SERVICE *No. 1199* BULLETIN

Date: February 16, 2009

MAIN LANDING GEAR TORQUE LINK INSPECTION

Figure 1

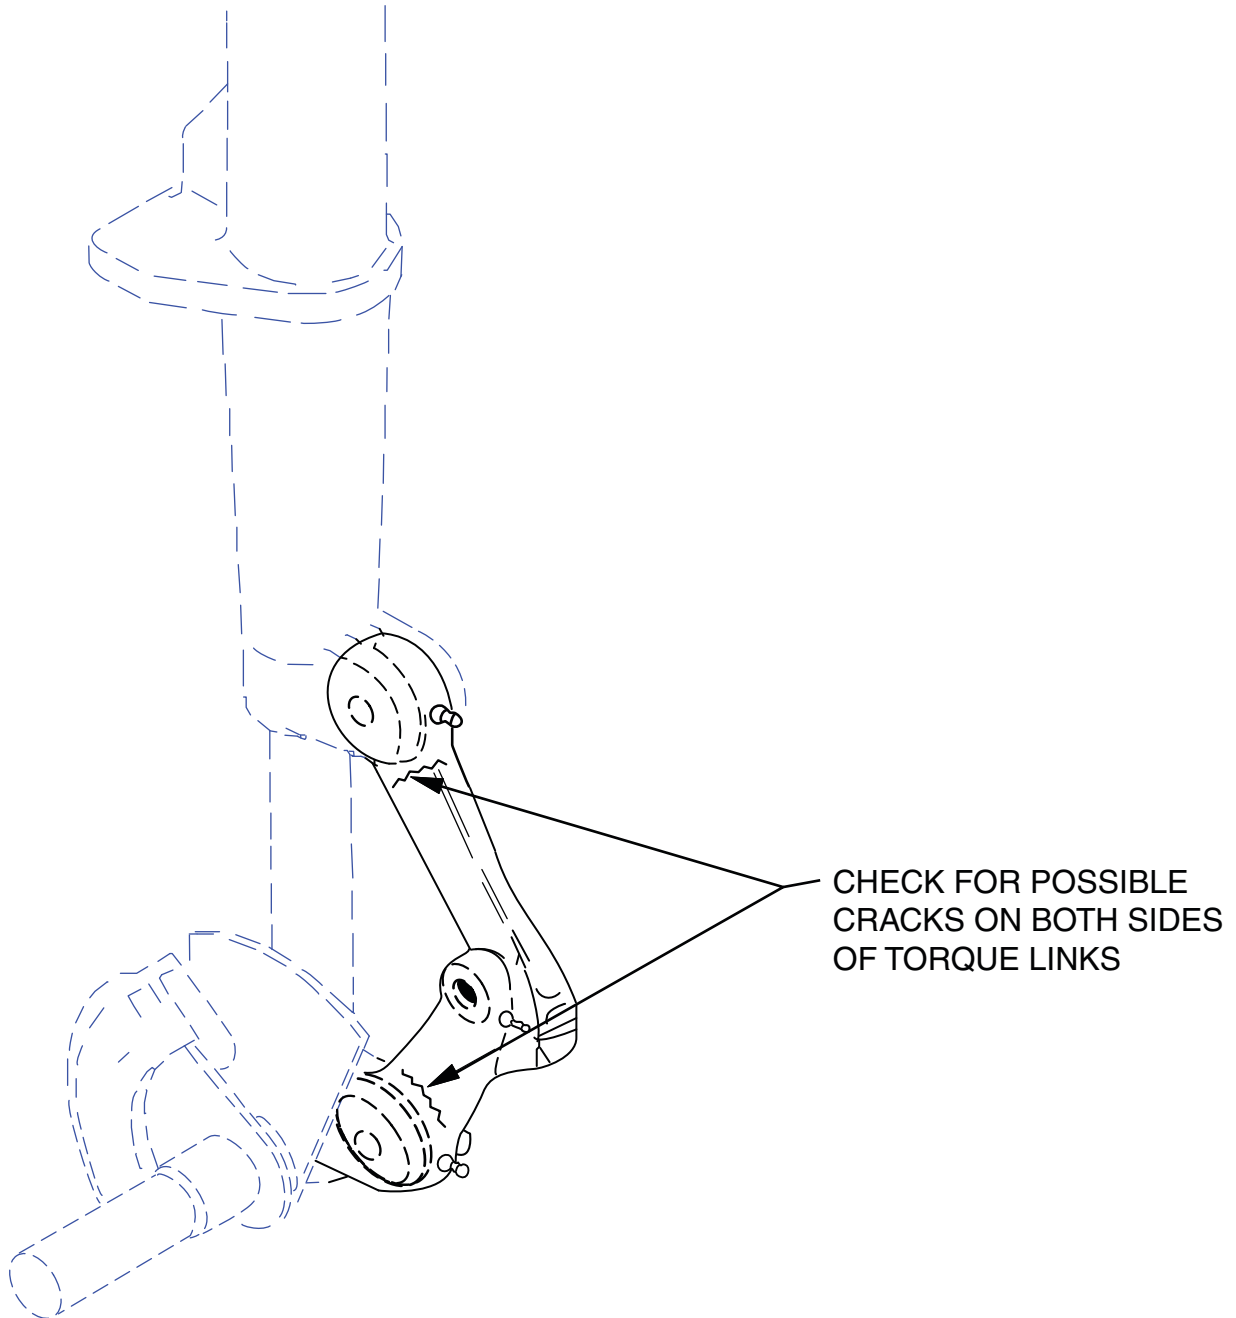
1. Locate the torque links, which are a component of the main landing gear, both left and right sides. There are a total of 4 torque links per aircraft. See Figure 1.

1. Place the aircraft on jacks and remove the main landing gear wheel assemblies in accordance with the Aircraft Maintenance Manual.
2. Remove paint from the area to be inspected, at the locations identified in Figure 1. (Use Cee-Bee A-202 paint stripper or equivalent).

3. Use isopropyl alcohol to wipe clean the area of the torque links where paint was removed.
4. Perform fluorescent penetrant inspection of the areas identified in Figure 1 per AC 43.13-1B.
5. If a crack is detected in any torque link, the torque links must be replaced in pairs, using the new style 78033-000 torque links. See MATERIAL REQUIRED section of this service bulletin.
6. If no crack is detected during the inspection, wipe torque links clean with isopropyl alcohol.
7. Apply primer to Torque links in area where paint was removed for inspection; using MIL-PRF-85582D Type I Class C2 primer; ANAC 10P8-10 Fluid Resistant Epoxy primer or any compatible epoxy primer. Apply top coat of paint using Dupont White (color code N00009 HN) Imron 5000-Texture A (smooth finish).
8. Reinstall main wheel assemblies.
9. Remove jacks from aircraft.

Figure 2
New Style Torque Link 78033-000

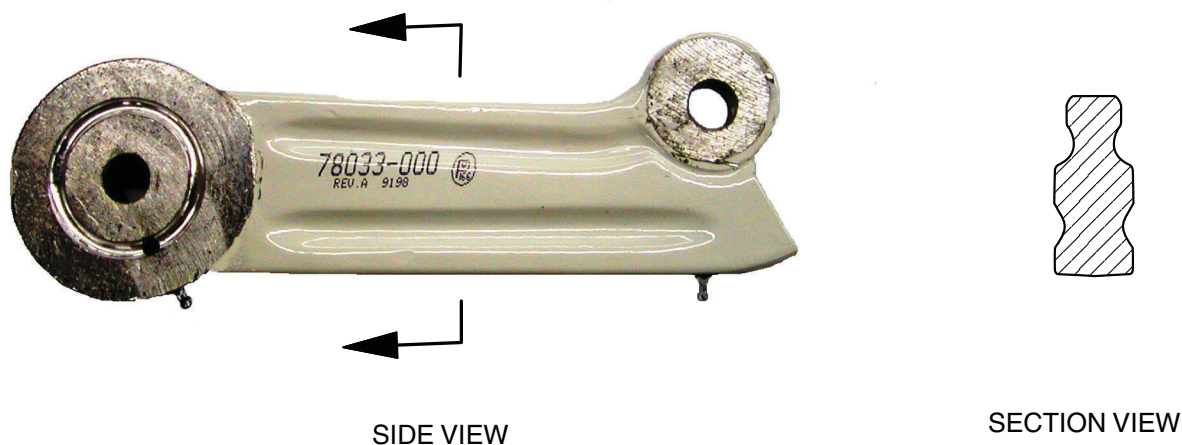
2. Determine which torque links are currently installed.
 - Figure 2 shows the new style torque link, Piper part number 78033-000. The midsection of this new style torque link is rectangular in cross section, with 4 longitudinal grooves (2 per side), as shown in the section view of Figure 2. The new style 78033-000 torque link is exempt from the recurring inspection requirement of Service Letter 600 and this Service Bulletin. Proceed to **Part III** if all four (4) torque links are the new style, Piper part number 78033-000.

- Not shown is the old style torque link, Piper P/N 65691-000, which was originally installed on the aircraft. This old style torque link differs in appearance from the new style P/N 78033-000 torque link at the midsection. The old style 65691-000 torque link has an oval cross section, whereas the new style 78033-000 torque link has a rectangular cross section, as described above. Any old style 65691-000 torque links installed on aircraft are subject to the inspection requirements and life limits described in **Part II** of this Service Bulletin.
